(R) BOLT, MACHINE – DOUBLE HEXAGON EXTENDED WASHER HEAD, PD SHANK, NICKEL ALLOY, UNS N07718, 185 KSI UTS MIN, .1900-32 UNJF-3A

SAE AS3243
SHEET 1 OF 2

REV. C

FIGURE 1 - BOLT

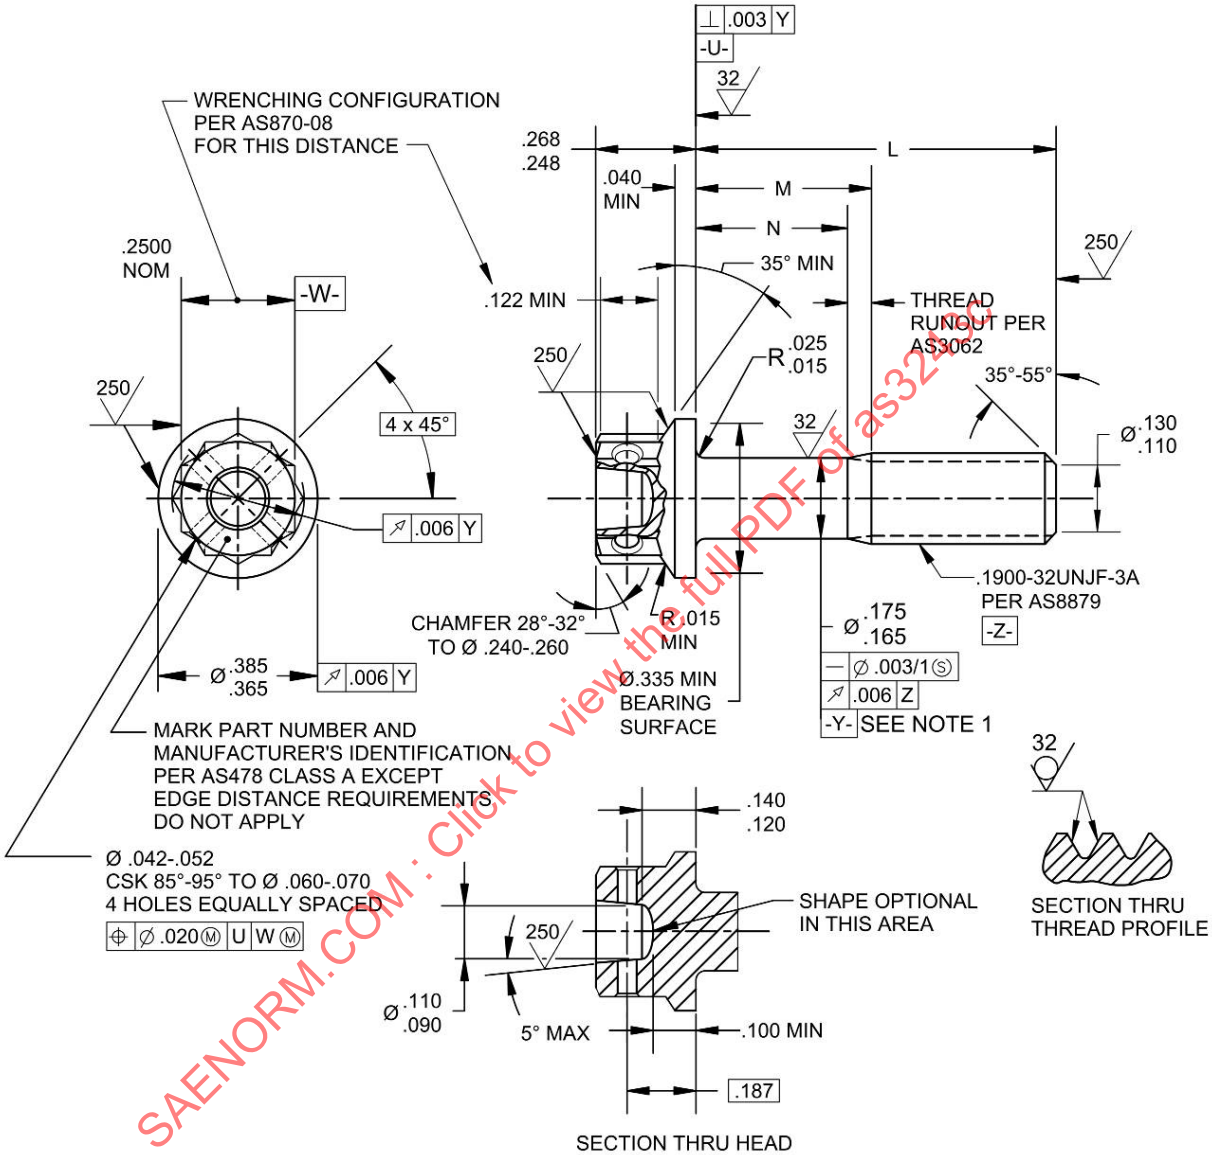
REVISE WRENCHING ELEMENT RUNOUT CALLOUT (RELOCATE FROM WRENCH FLATS TO POINTS). REVISE THREAD SPECIFICATION TO AS8879. REVISE LIGHTENING HOLE CONFIGURATION (ADD SECTION VIEW) TO ALLOW OPTIONAL SHAPE AT BOTTOM OF HOLE, ADD SYMBOL FOR MMC TO POSITION TOLERANCE FOR SAFETY WIRE HOLES, AND FIGURE 1 REDRAWN.
